***Environmental Protection Act 1986*****Section 43A****NOTICE OF DECISION TO CONSENT TO AMEND A REFERRED PROPOSAL  
DURING ASSESSMENT****PERSON TO WHOM THIS NOTICE IS GIVEN**

Greenbushes Lithium Mine: Waste Rock Landforms, Salt Water Gully Dam and additional clearing for infrastructure  
Assessment No. 2496

Attachment 1 - Amended proposal content document and figure/s showing the new approved proposal

Figure 1-10 Rehab Material Stockpiles Amendment

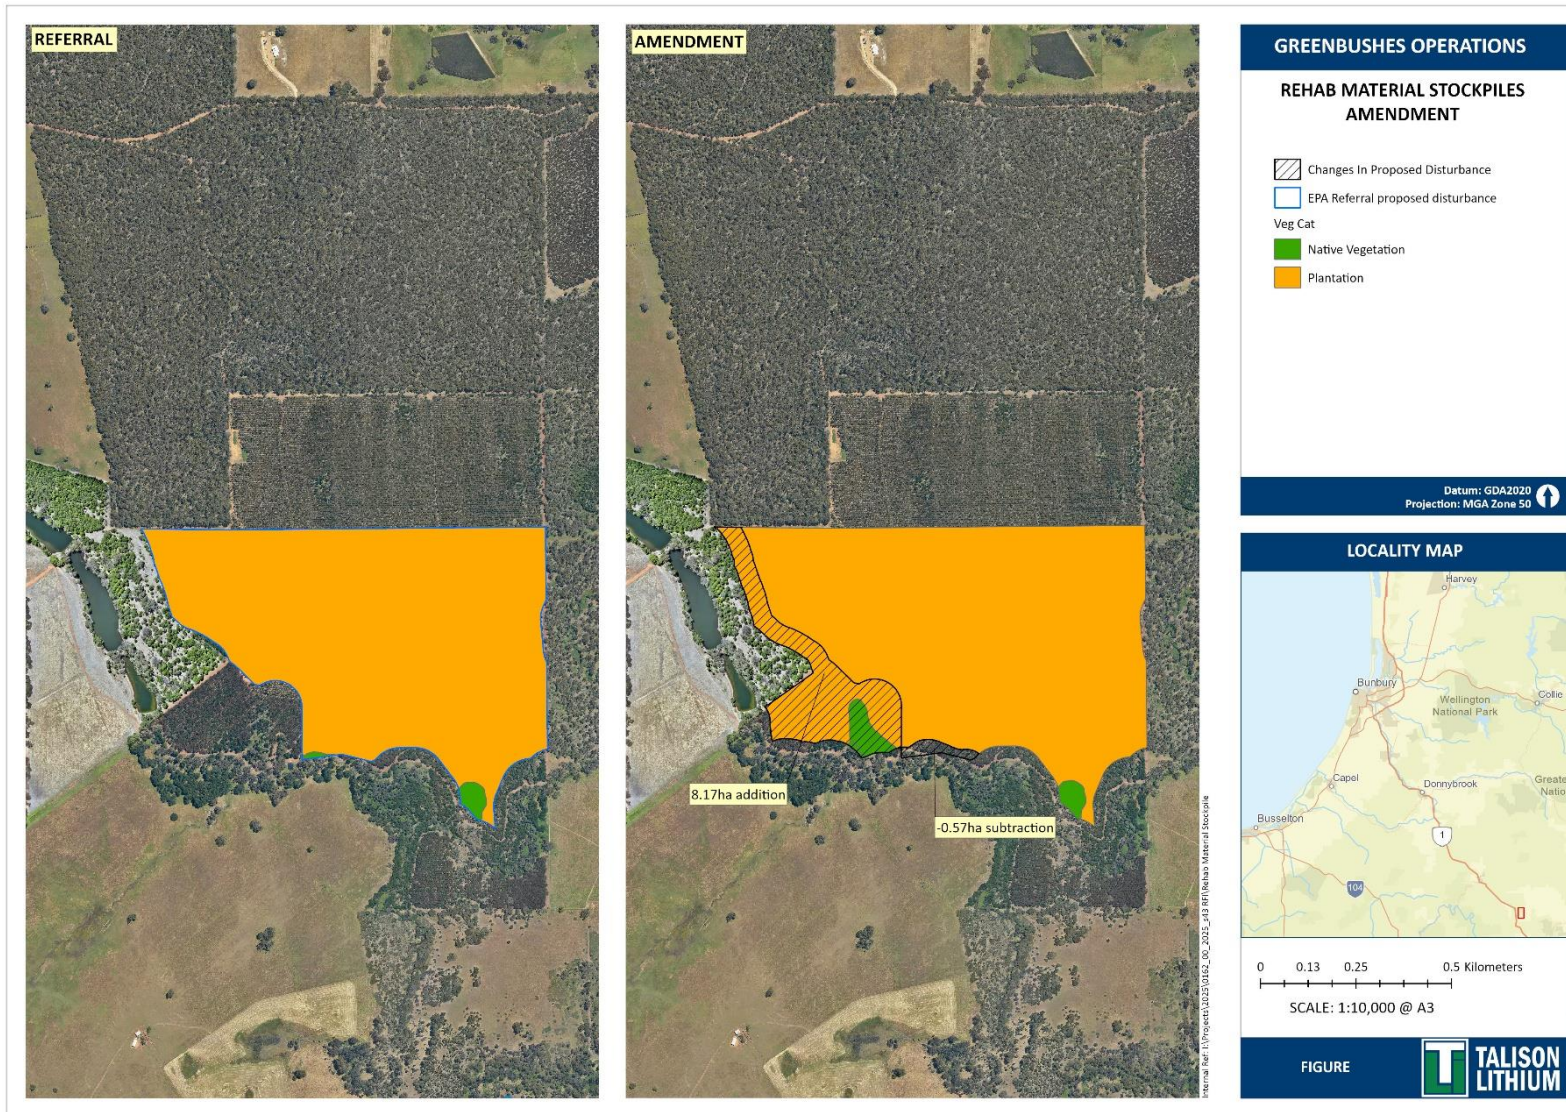
- re-design the rehabilitation material stockpiles (RMS) footprint (2 ha increase)
- re-design the waste rock landforms (WRLs) S2 and S8, including the removal of the proposal element Mixed Use Area to integrate the area into the S2 footprint (no change in overall disturbance)
- remove the referred laydown area east of Salt Water Gully Dam (removed with the heritage buffer)
- increase the total area for operational element WRL Construction by 63 ha (from 727 ha to 790 ha)
- administrative changes to clearly define the proposal elements and correct an error in the proposal content document to align the referred area of the DE with the referred spatial data (2,826 ha corrected to 2,824 ha).
